# UNITED STATES PATENT AND TRADEMARK OFFICE

10/581,314

<b>Office Action Summary</b>	<b>Application No.</b> 10/581,314	<b>Applicant(s)</b> LIMMA ET AL.	
	<b>Examiner</b> Robert F. Long	<b>Art Unit</b> 3764

### **DETAILED ACTION**

Fig. 3

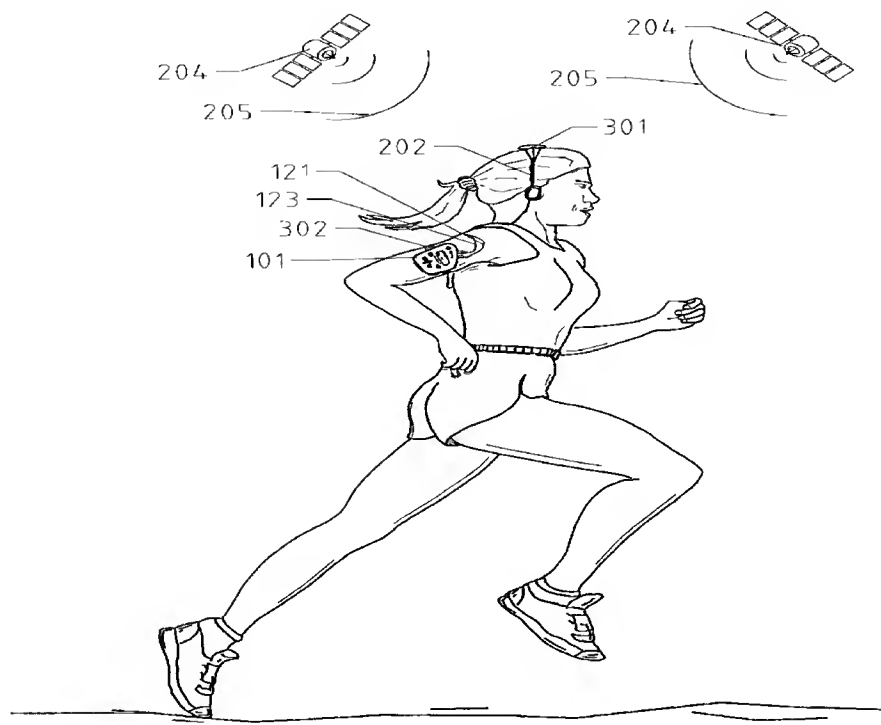
**Regarding claims 1-26**, Root et al. discloses a measuring device (feedback device 101 figure 6) and system (feedback device 101, headphones 202, and antenna 301, with satellite 204 to form communication). See figure 3 below -

Fig. 6

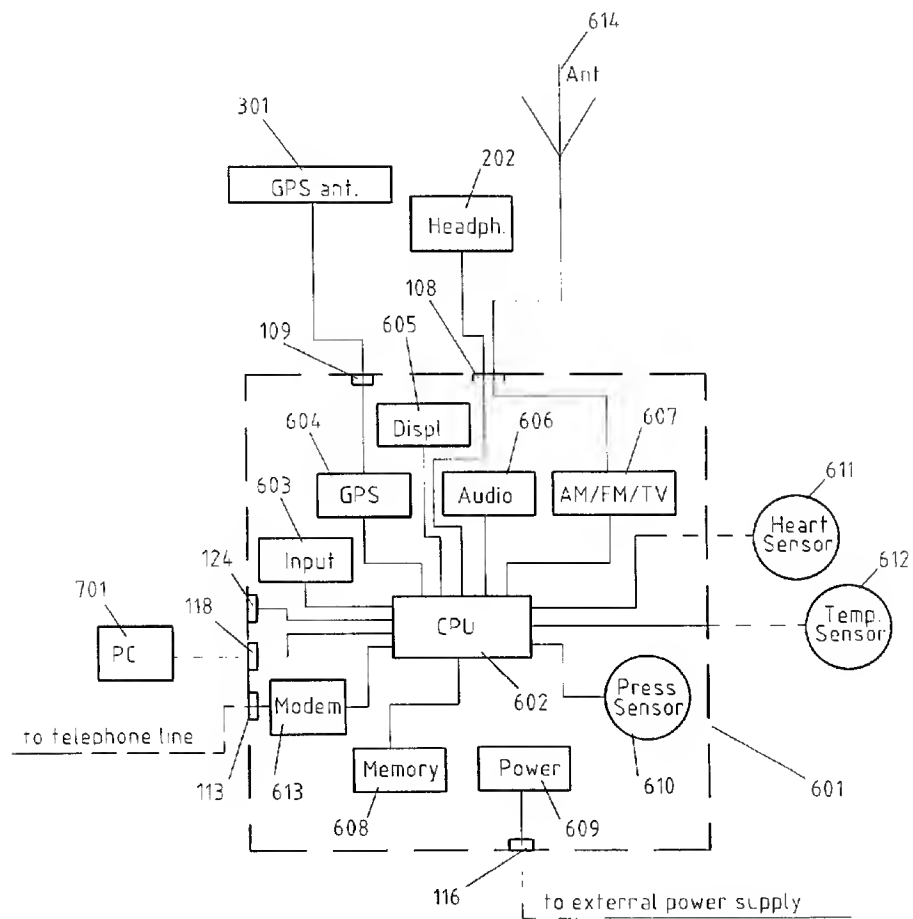
comprises: a measurement device (feedback device 101 having measurement barometric sensor 610, figure 6) comprising a first processor (CPU 602, figure 6), a plurality of measuring elements (sensors 610-612, figure 6) configured to measure a plurality of quantities relating to a sports activity, a first memory (memory 608, figure 6) configured to store measurement data provided by the measuring elements comprising a GPS receiver (604, figure 6), barometric sensor (610), heart sensor (611, figure 6), and a thermometer, (body temperature sensor 612, figure 6), and a transmitter (modem 613, figure 6) configured to transmit sports activity (running figures 2-3) information during the sports activity (running figures 2-3) to at least one a receiving device via a local communication link according to a communication protocol, (feedback transfer column 8, lines 59-67); and the receiving device (GPS receiver module 604, figure 6) comprising a receiver (antenna 301, figure 6), configured to receive a transmission from the measurement device during the sports activity (running figures 2-3) via a local communication link, wherein the transmission includes sports activity (running figures 2-3) information measured with the measurement device (feedback device 101, figure 6), a second memory (built in memory of GPS receiver module 604, figure 6) configured to store at least one definition based on which a predefined set of pieces of sports activity (running figures 2-3) information is selected from the received sports activity (running figures 2-3) information, and a second processor (built in processor of GPS receiver module 604, figure 6 ) configured to select the predefined set of pieces of sports activity (running figures 2-3) information from the received sports activity (running figures 2-3) information based on the at least one definition, which is defined based on the sport in

question, stored on the second memory (built in memory of GPS receiver module 604, figure 6); and at least one feedback device (feedback device 101, figure 6) configured to provide the at least one individual with feedback on a user interface display based on the selected sports activity (running figures 2-3) information, (column 4, lines 4-67, column 5, lines 1-67, figures 1-12). See figure 6 below for electrical schematic of the feedback device –

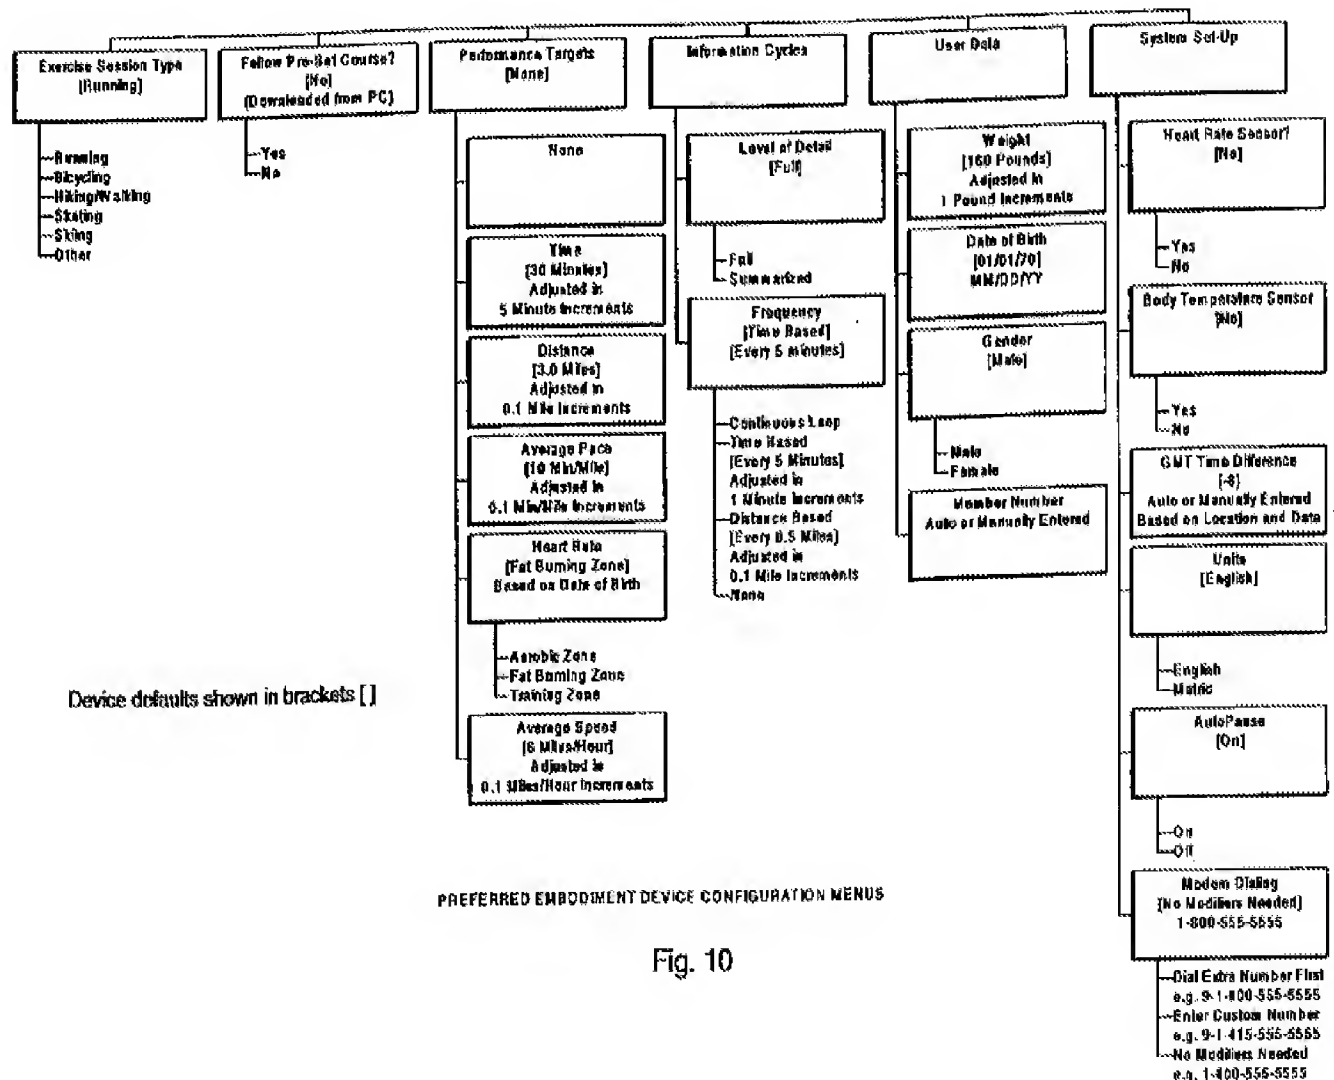
Root et al. also discloses the system and method comprises the feedback device (101, figure 6) a display having graphical features, geographic position on display 112, column 4, lines 10-15), voice signals (audio module 606, column 35-64), ear piece, (headphones figures 2-5), and a speaker (column 11, lines 1-5). Root et al. also discloses a menu and selection choices for the desired activity, (column 6, lines 42-49, figure 10). See figure 10 below for menu selection and activity settings –

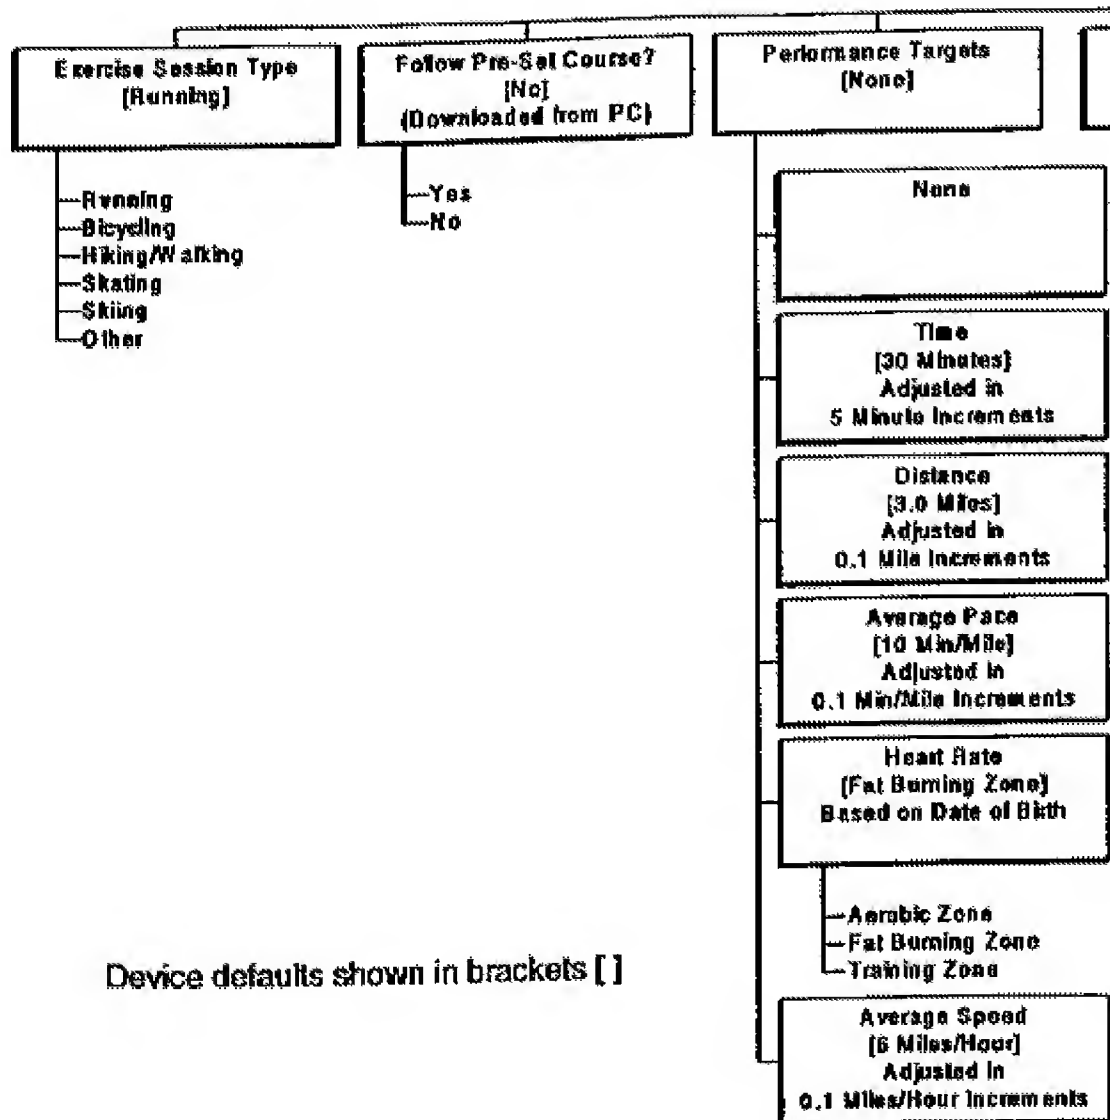
Also in figure 10 Root et al. shows the selection of the sport in question (run, bike, skate, ski, and other) and target/pieces of information to inquire about the sport in question –

**Fig. 8**

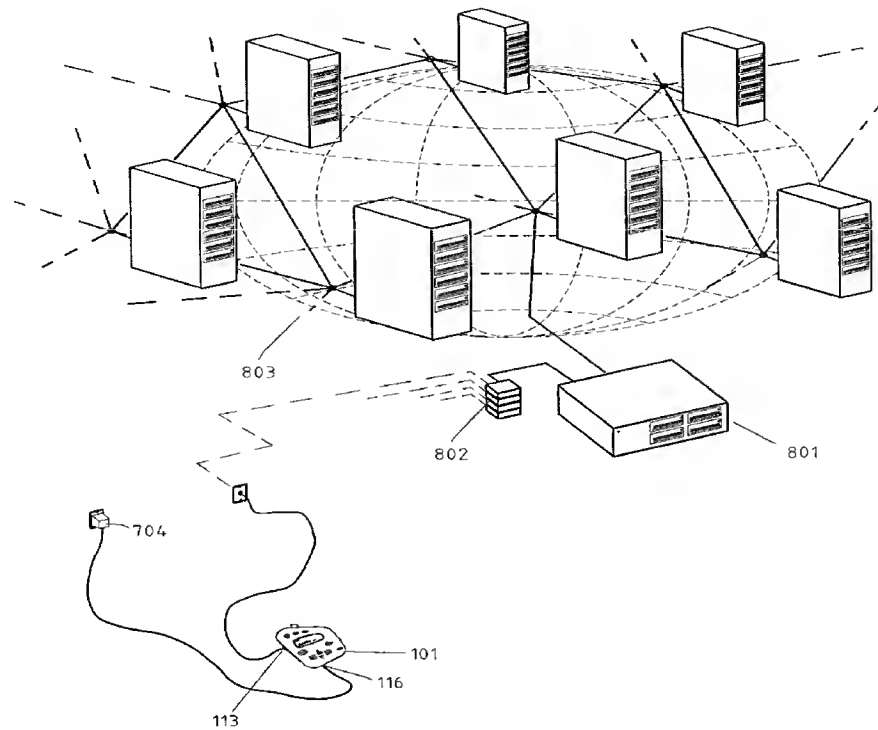
Applicant's arguments filed 10/19/09 have been fully considered but they are not persuasive. Per the amendment to the specification and drawing errors examiner contends it is not clear how many devices, interfaces, and/or displays there are and the arguments with respect to a plurality of receiving devices is moot. Also, with respect to root et al's feedback device only being a single device, Root discloses the feedback measuring device interacting/transmitting with more than once receiving device, (column 6, lines 1-67, figures 8-9).

Root et al. states: “*GPS-based personal performance monitor and feedback device 101 connected to a remote computer 801 and modem bank 802 via its internal modem 613 and a standard telephone line plugged into connector 113*”, (column 6, lines 12-29, figure 8).

Figure 8 below shows the feedback measuring device transmitting data to a plurality of receiving devices -
